Planning Application Ref: EG/20/19/T

Location: 19 Holmdale, Eastergate, PO20 3AA

Description of works: Crown lift westerly spread to 3m and lateral reduction of northern spread by 2m and western spread by 0.5m to 1 No. English oak tree

Figure 2 Positions of final cuts

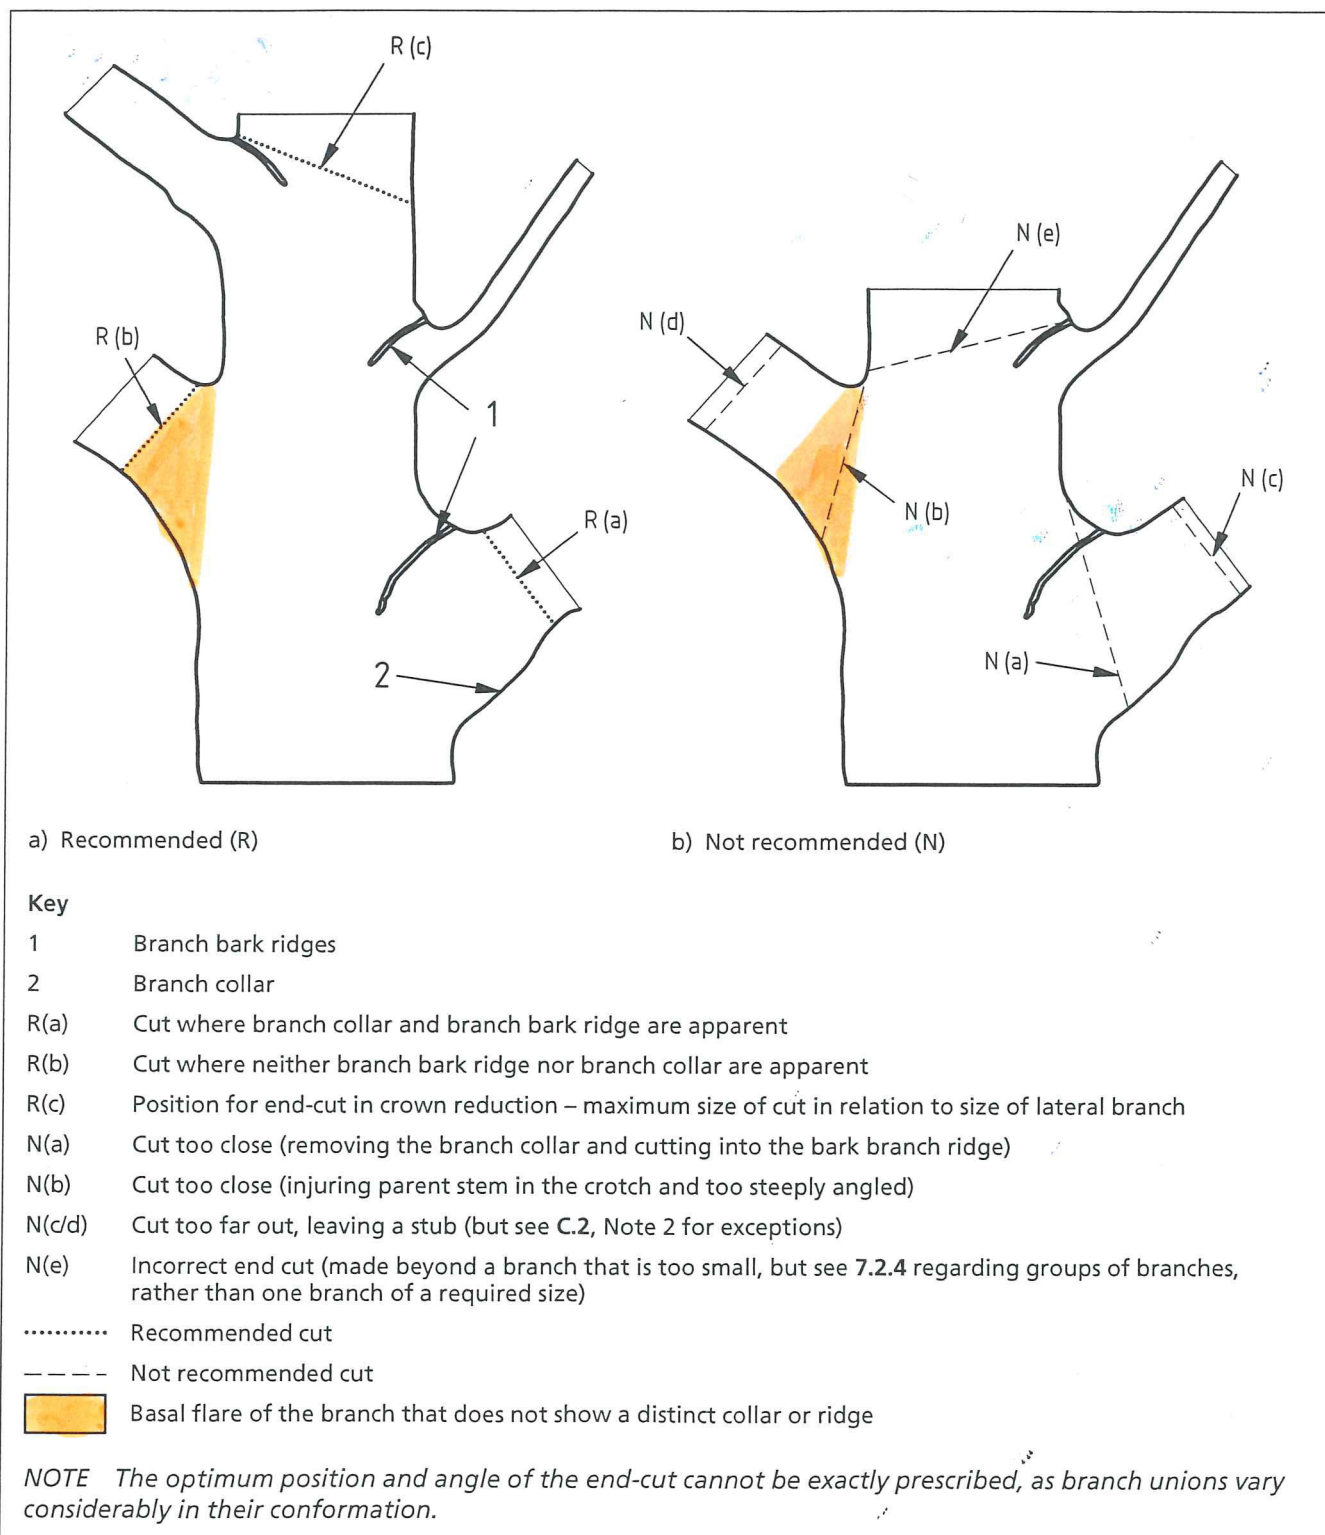
- Where whole branches are to be removed and final cuts made close to the trunk or branch union they are to be made as shown in Figure 2 of BS3998:2010
- Where branches are to be shortened back the final cuts are to be made at the correct angle shown in BS3998:2010 and adjacent to a live bud or lateral.
- Remove small branches (<50mm diameter) as necessary to achieve all elements of the approved works. No pruning wounds should exceed this size.
